BOARD ACTION REPORT – APPEALABLE ITEM

Project Name: Seagate Villas
Project Location: 1017 Bucida Road
Request: Class V Site Plan, Landscape Plan and Architectural Elevation Plan for the demolition of an existing residential structure and construction of a new three-story townhouse building containing three units.

---STAFF REPORT---

ITEM: Class V Site Plan, Landscape Plan and Architectural Elevations for Seagate Villas, associated with the demolition of an existing residential structure and construction of a new three-story townhouse building containing three-units.

1 SITE PLAN
1'-0" = 1'-0"

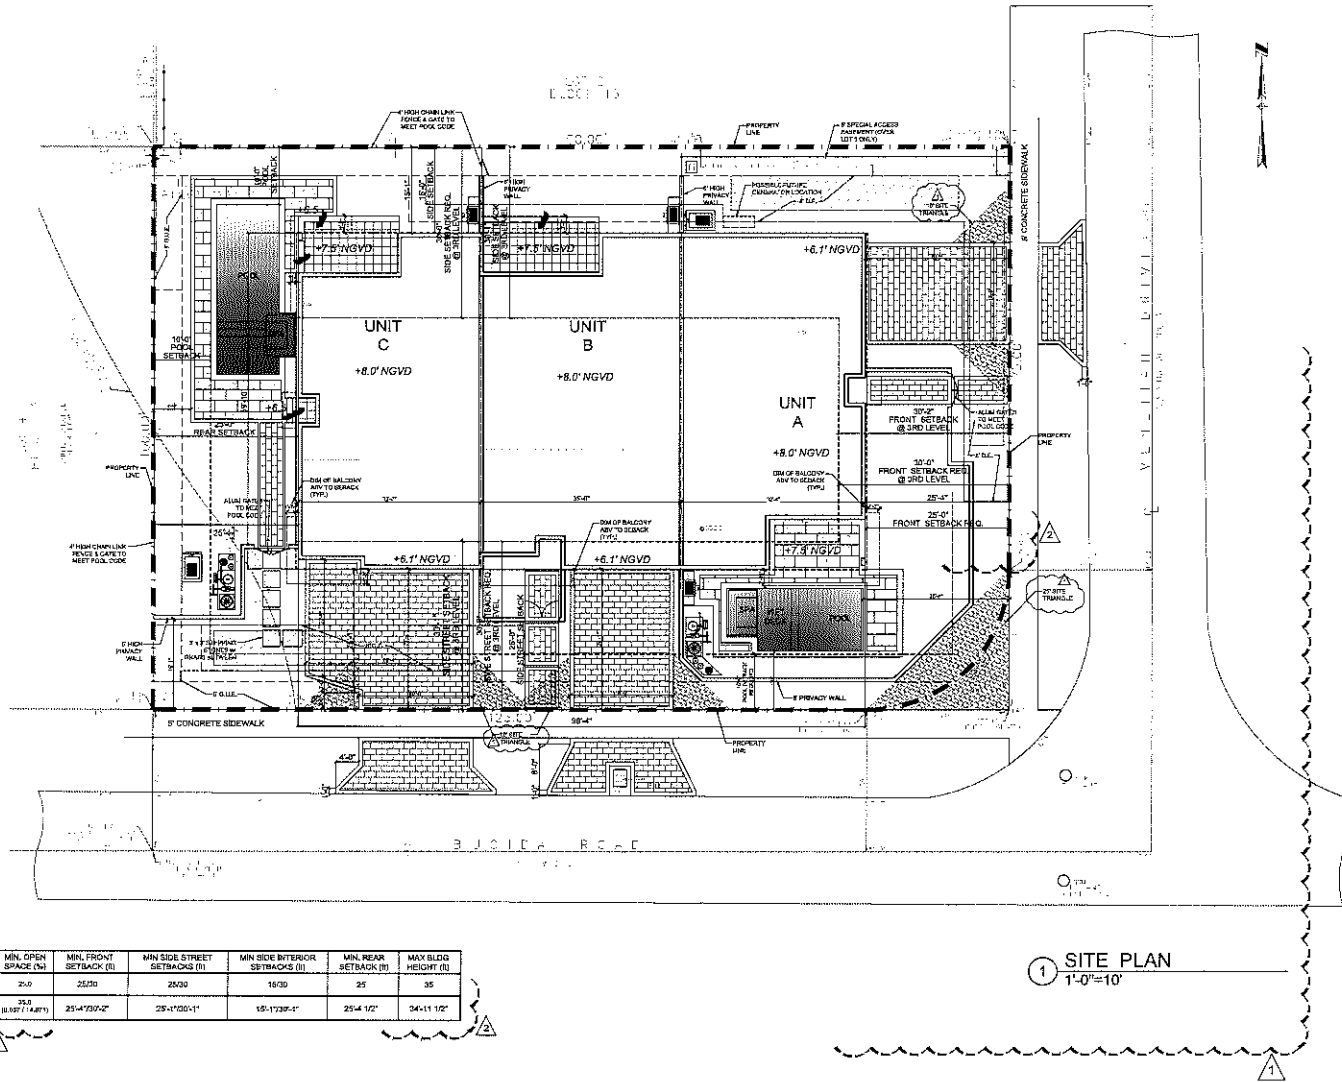
- That the proposed generator is removed from the site plan and addressed during the building permit process.
- That the photometric plan is provided and worked out with staff.

2 SOUTH ELEVATION (BUCIDA)
1/4"=1'-0"

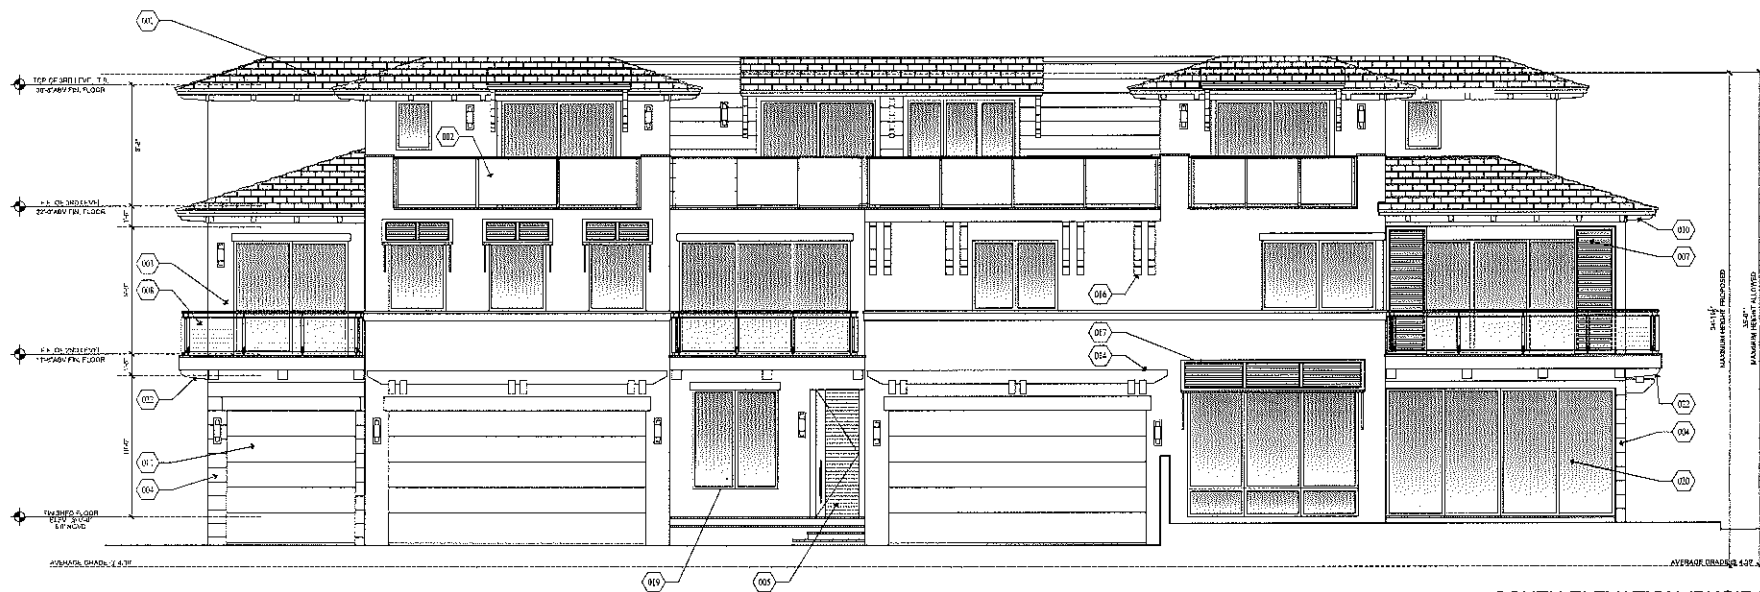
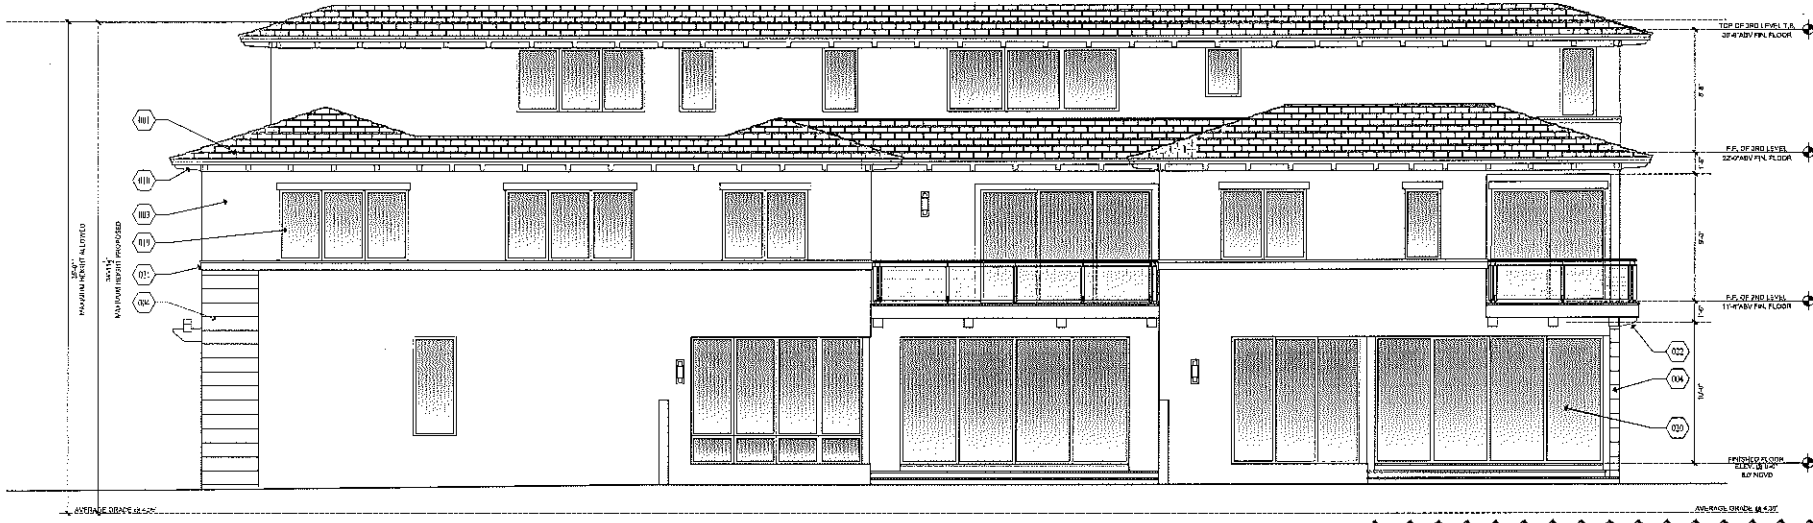
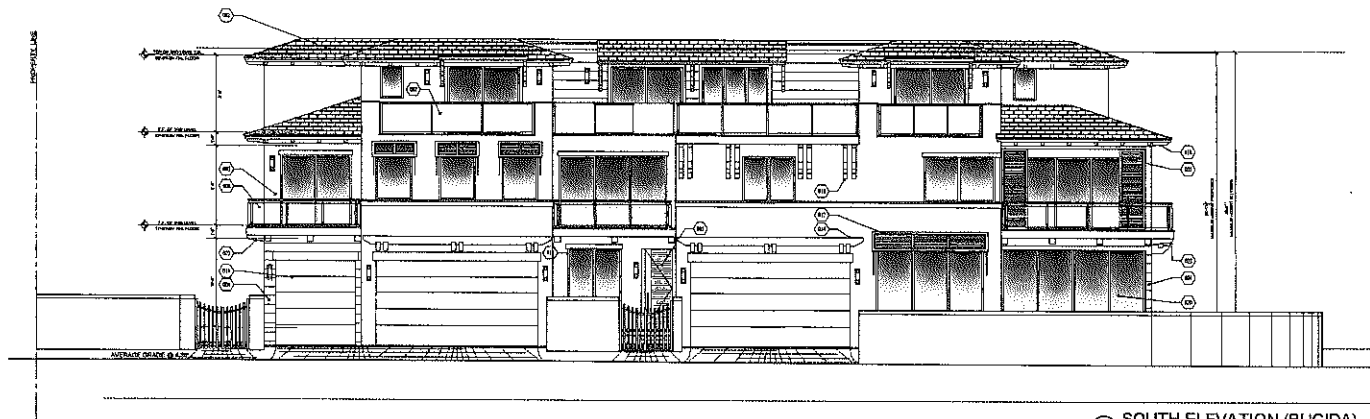
1. That revised architectural elevation plans are submitted to note that the color of the privacy walls matches the Toque white walls of the building prior to the certification of the site plan.
